SEABROOK STATION  
Engineering Office:  
1671 Worcester Road  
Framingham, Massachusetts 01701  
(617) - 872 - 8100

SBN-280  
T. F. B 7.1.2

Subject: Meeting Notes; Instrumentation and Controls Systems Branch (ICSB)

We have attached notes from the May 12 and 13 ICSB review meetings conducted at the office of United Engineers (Philadelphia, PA). This meeting was based on the ICSB Requests for Additional Information which were forwarded in Reference (b) and (c). The notes also include those items discussed at the March 23-25 review meeting that have been revised. We have indicated the date of the review meeting at which the response or a revision to a response was made. The March 23-25 meeting notes, (Reference d,) are not included with this letter.

RADIATION DATA MANAGEMENT  
SYSTEM BLOCK DIAGRAM

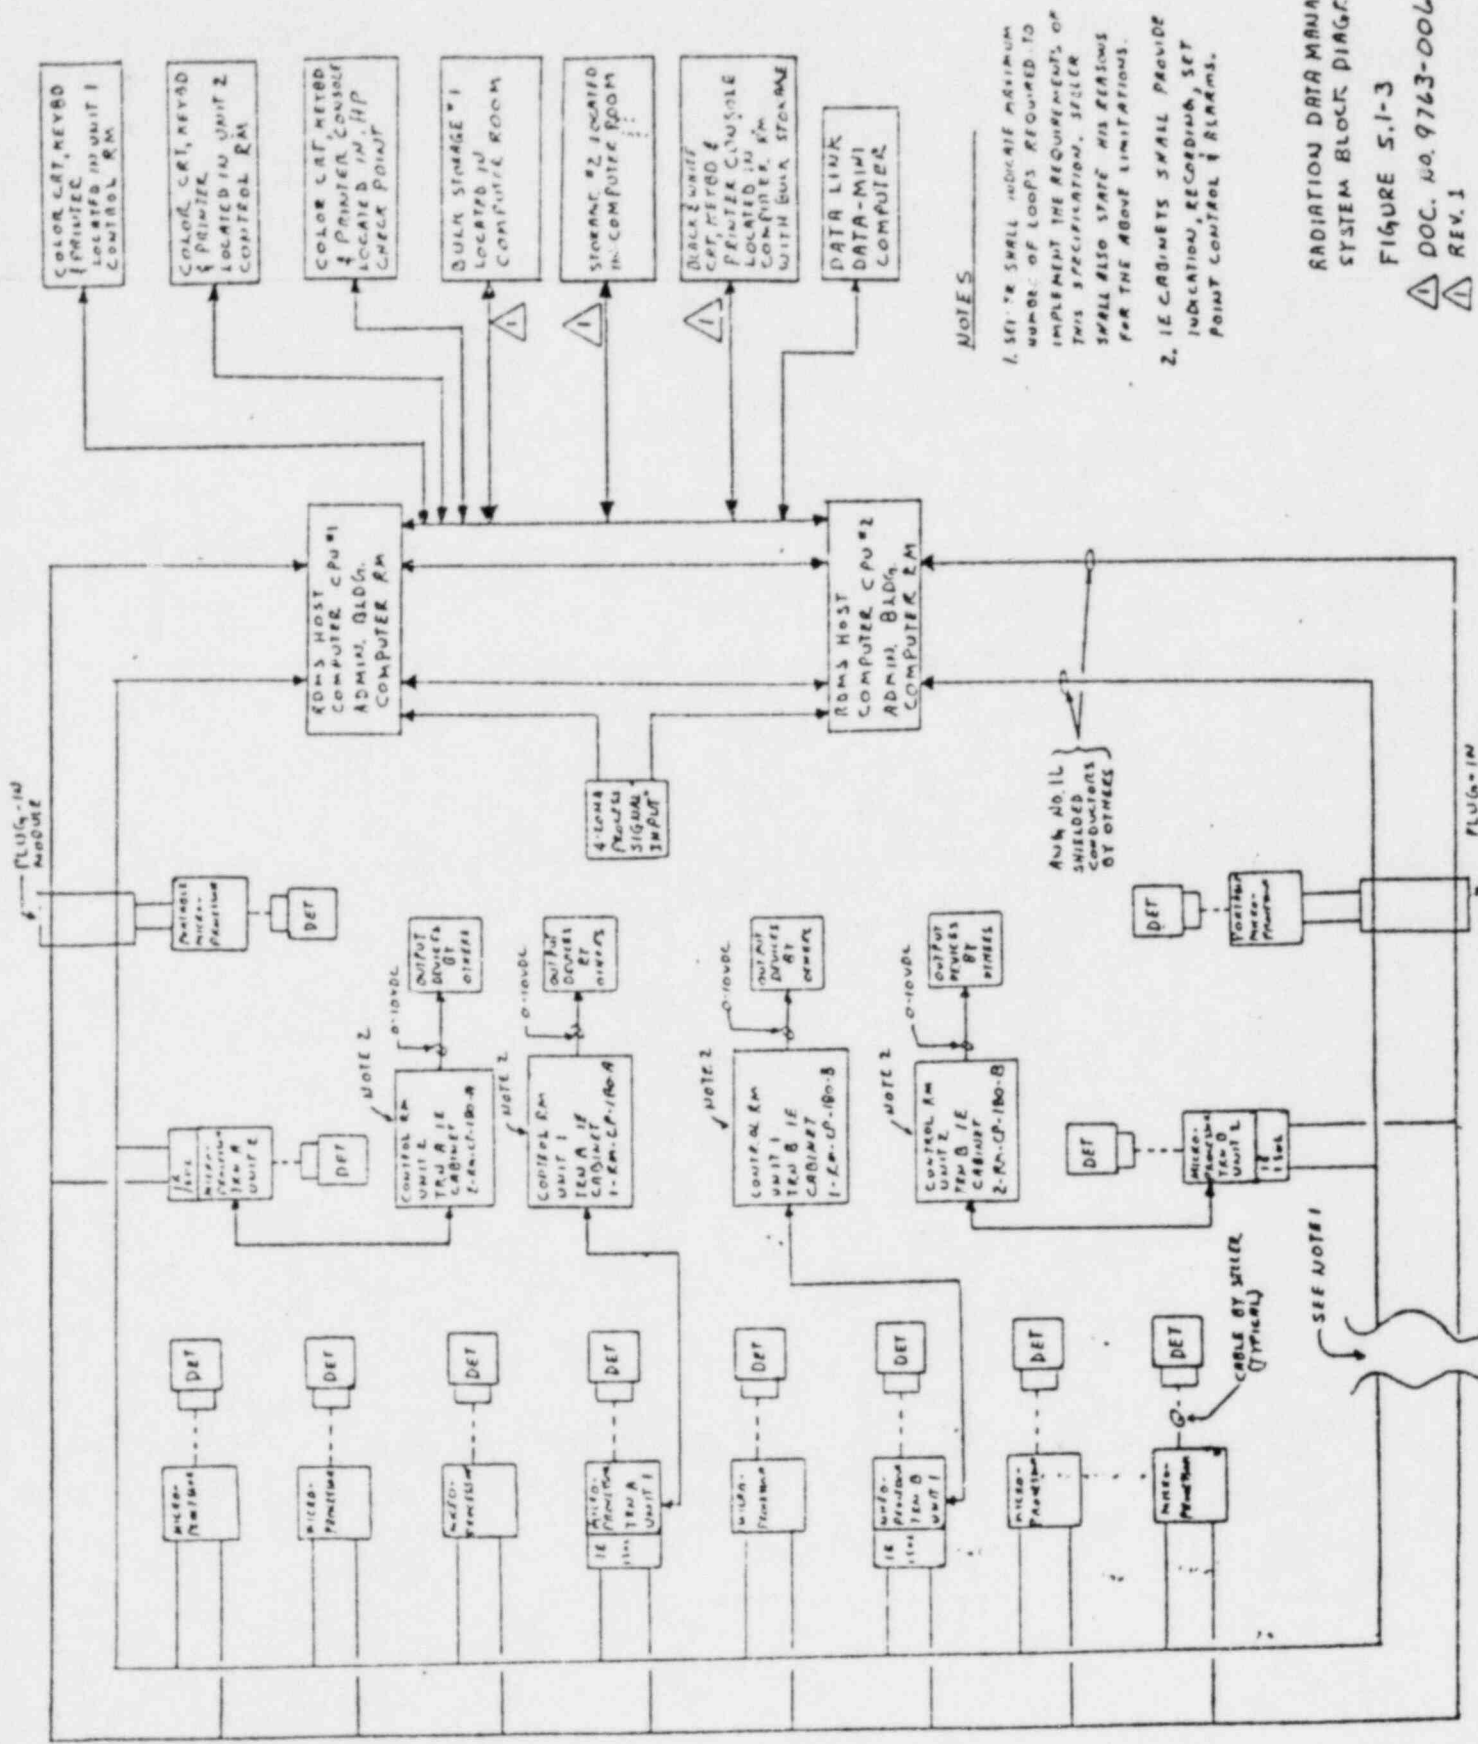
RESPONSE: The RDMS is functionally identical to the systems installed at  
5/12 Byron-Braidwood, St. Lucie 2, Waterford 3, SNUPPS and Comanche  
Peak.

FIGURE 1

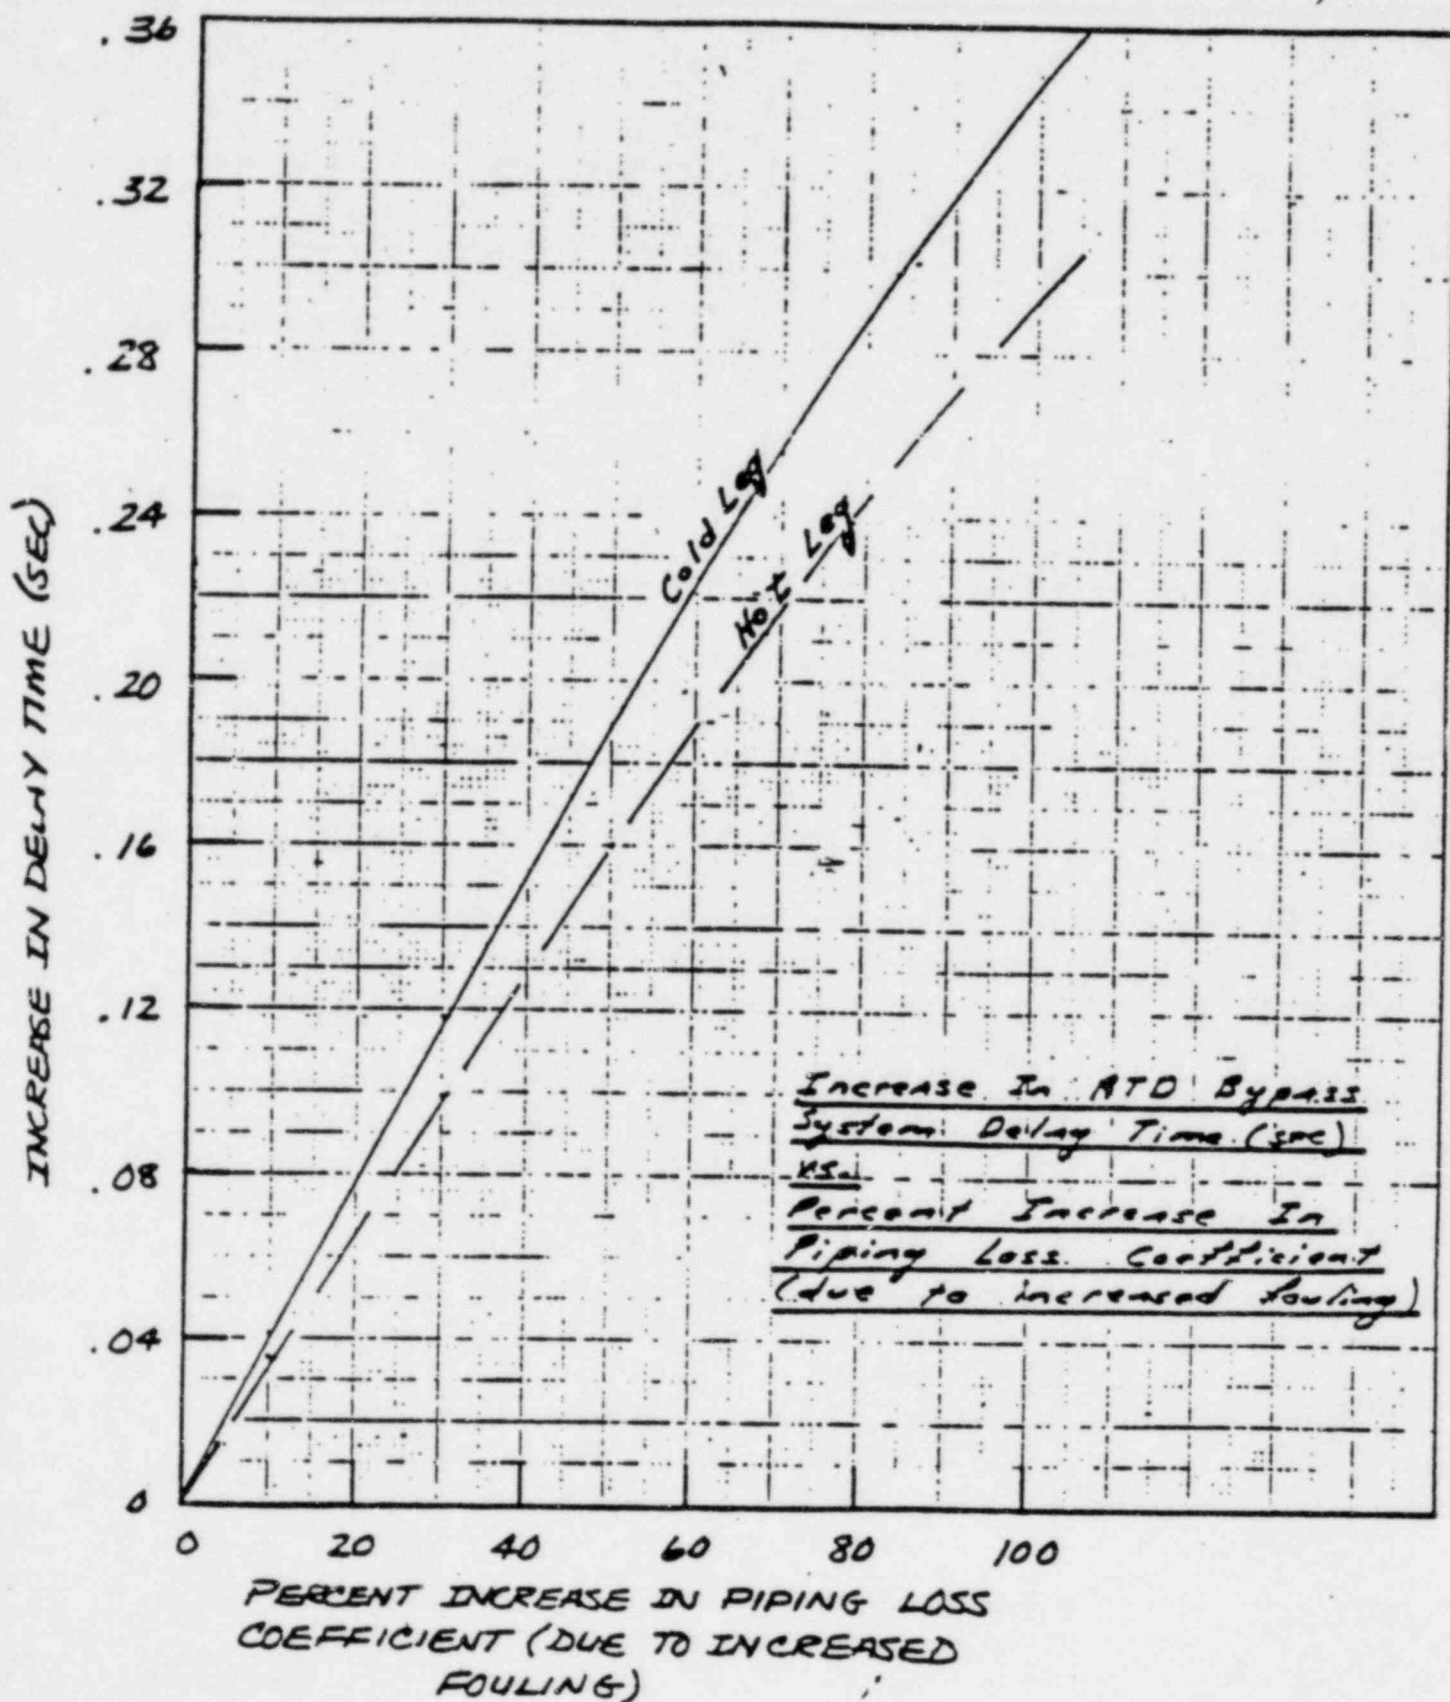
In part 2 of the evaluation a parametric study was performed to determine the effect of increased fouling on the delay times. Figure 1 is a plot of the increase in the hot and cold leg transport delay time as a function of the percent increase in piping loss coefficient (due to fouling). Loop 1 was used as a representative loop to generate this plot but we can expect Loops 2, 3, and 4 to behave similarly. Summarizing this part of the study, the hot leg loss coefficients would have to increase by the amounts listed below before the 1.0 second maximum delay time would be reached.
